# Technical Bulletin

Bulletin No: TCH-002-014

## subject: Bendix<sup>®</sup> Air Disc Brake Actuator Vent Hole Orientation

Air Disc Brake Actuator - Bottom View Shown

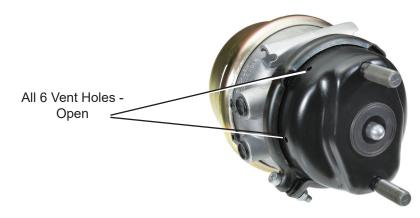
Plugged Vent (All other vent holes may be open or closed)

Open Vent (Bottom vent hole <u>must</u> be open)

Action: Vehicles with Bendix<sup>®</sup> brand air disc brake actuators should be inspected to verify that the vent hole closest to the bottom of the actuator is open. If a plug is found in this location, it must be removed to allow proper draining. The removed plug can be discarded. It is not necessary to place it in the other open port. Removal of the plug is easily completed by pulling it out with a pair of needle nose pliers. Note that the removal of this plug will not impact the actuator warranty.

Since testing has shown that having more than one vent open does not impact either performance, or the life of the product, the plugs are being removed from all Bendix air disc brake actuator designs. This will eliminate the possibility of water and contaminants collecting in the actuators, reduce part numbers and inventories, and make servicing the actuators easier.
